ADDENDUM NO. 4

Date: September 25, 2023

Project Name: Traffic Operations Facility, IRC-2104

Bid Number: **2023059**

Cert. No.: 12,456 A6.21

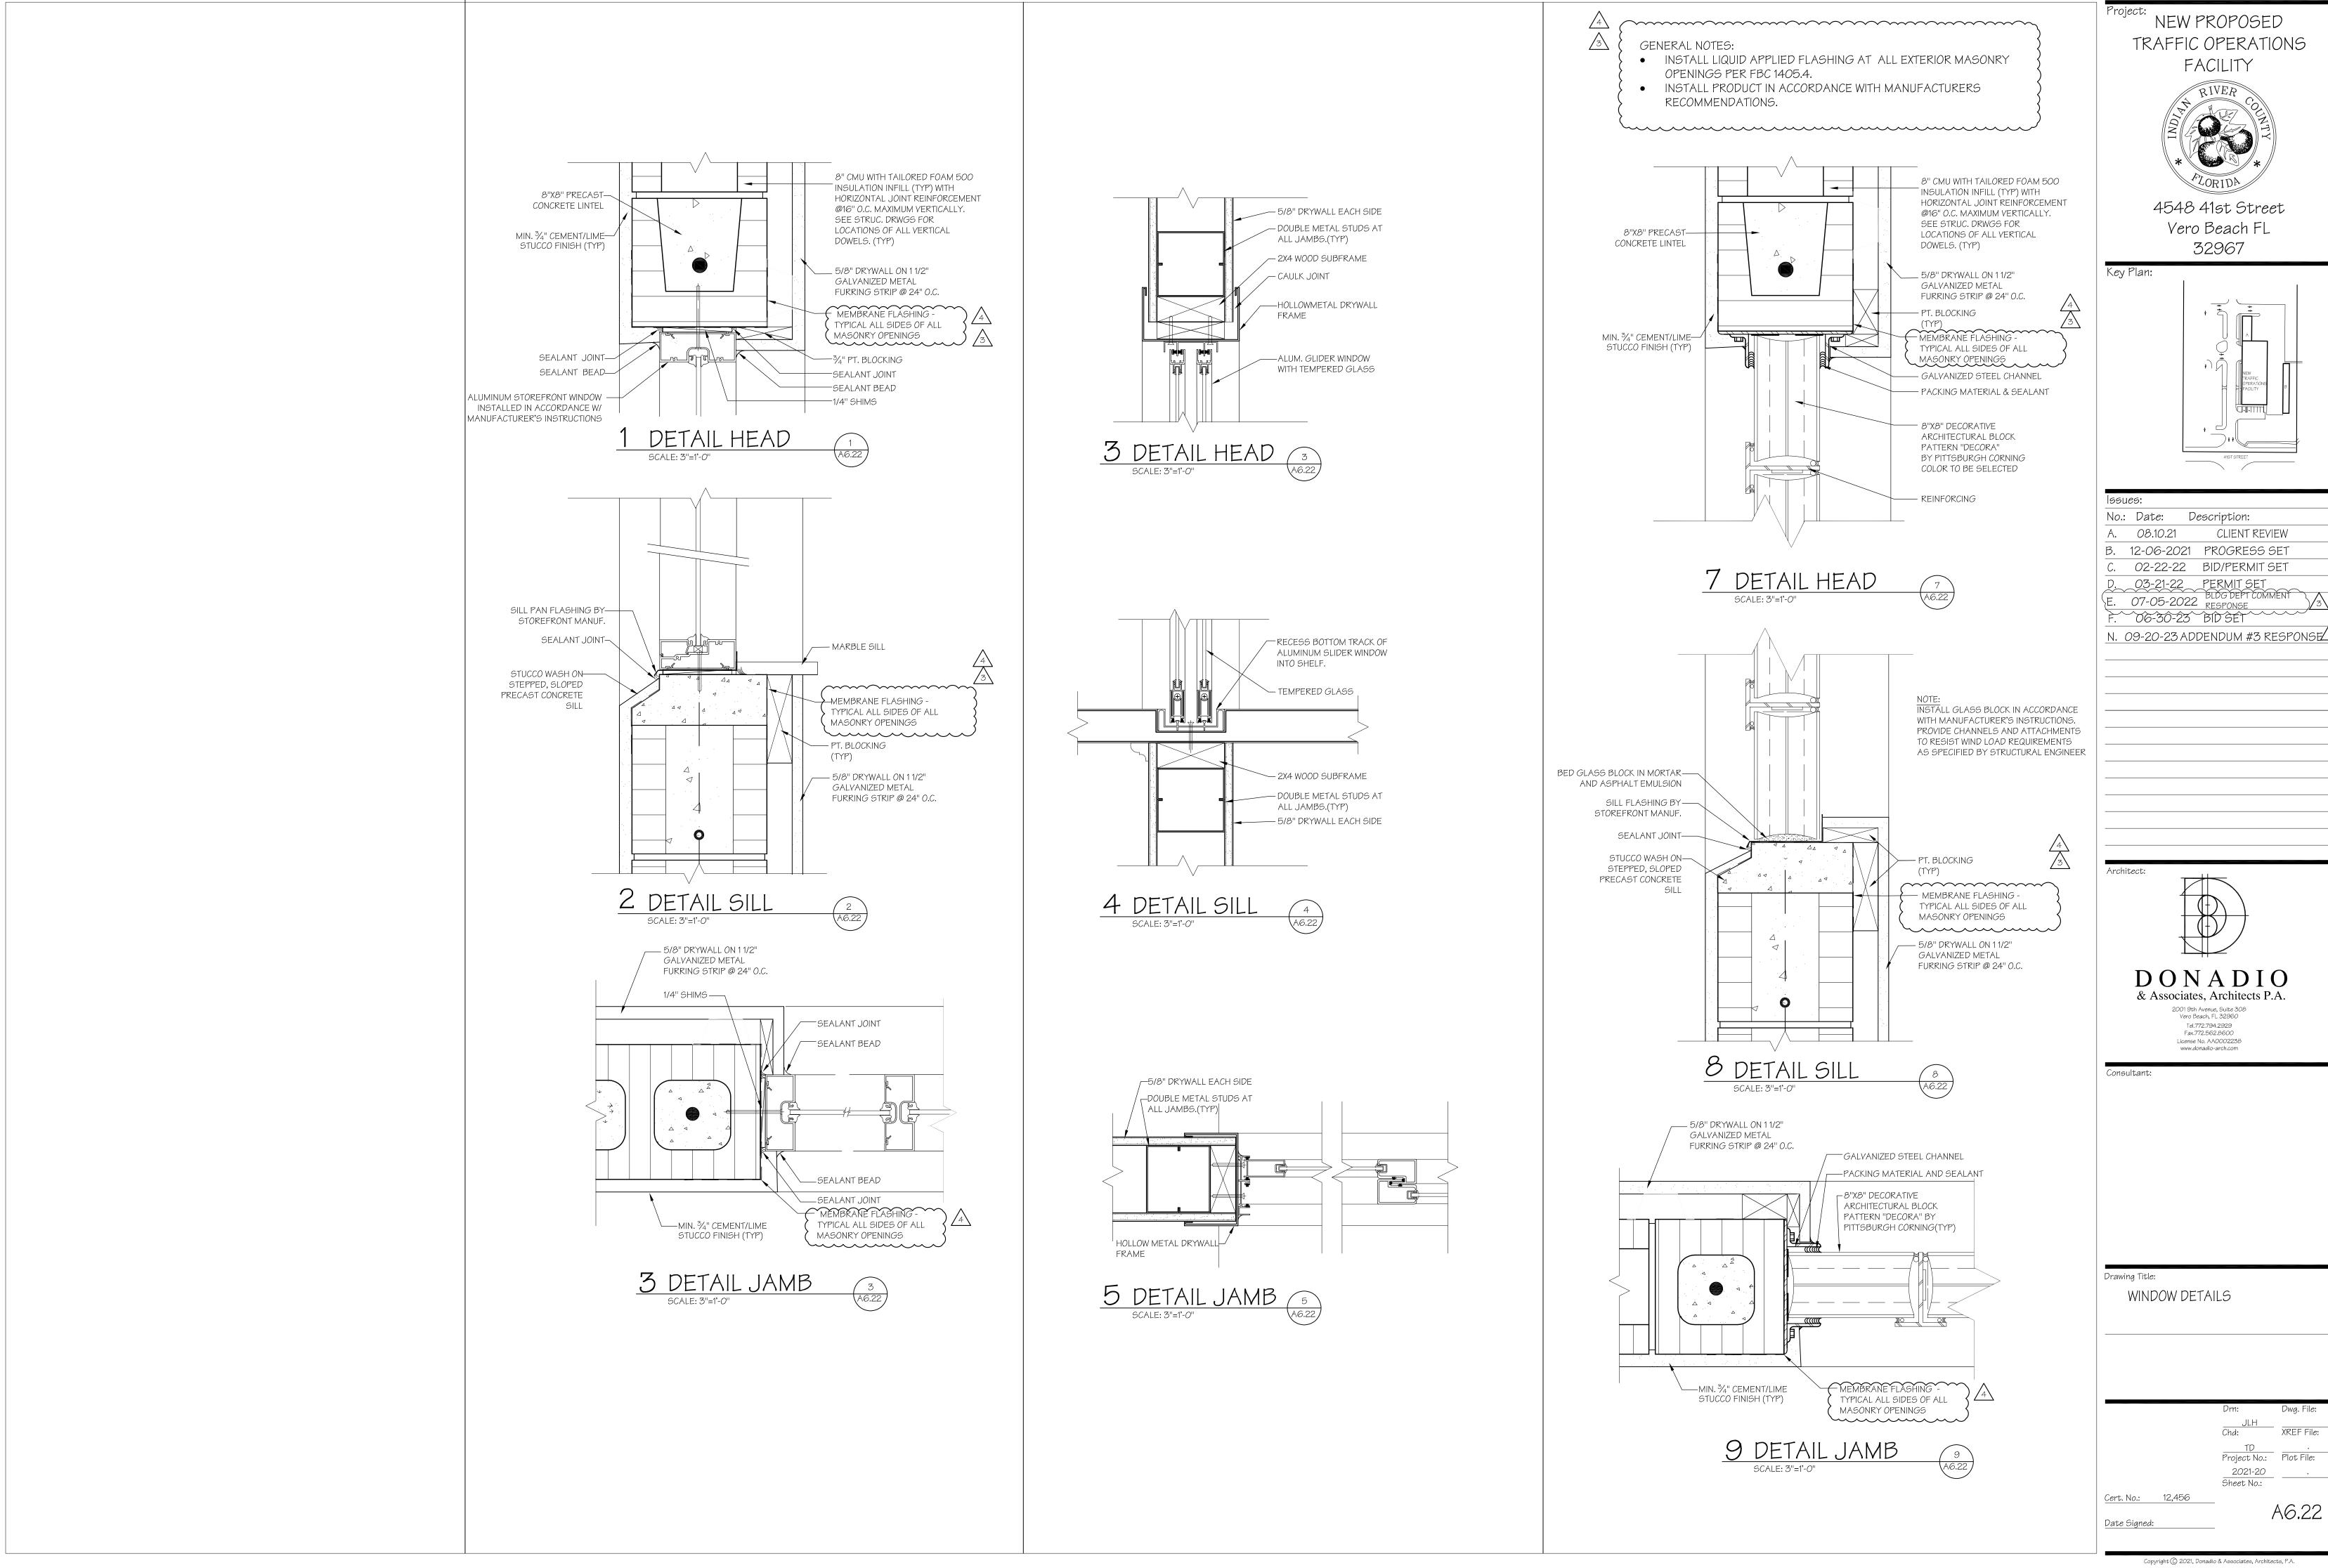
- Answer 29. Generator Slab elevation to be 25.50. See Attachment SK-1 for Generator Slab design.
- Question 30. Door Details on A6.20 & A6.21 and Window Details on A6.22 indicates a self-adhering membrane, typical of all masonry openings. General Notes on A6.22 indicates it can be a liquid applied product. Please provide specifications for this liquid applied product or cementitious applied product.

- Answer 30. Liquid Applied Membrane <u>Basis of Design</u>, Protecto-Wrap LWM200. See revised Window and Door Details Sheets A6.20, A6.21, A6.22 and attached LWM 200 Technical Data Sheet.

INSTALL LIQUID APPLIED FLASHING AT ALL EXTERIOR MASONRY OPENINGS PER FBC 1405.4.

INSTALL PRODUCT IN ACCORDANCE WITH MANUFACTURERS RECOMMENDATIONS.
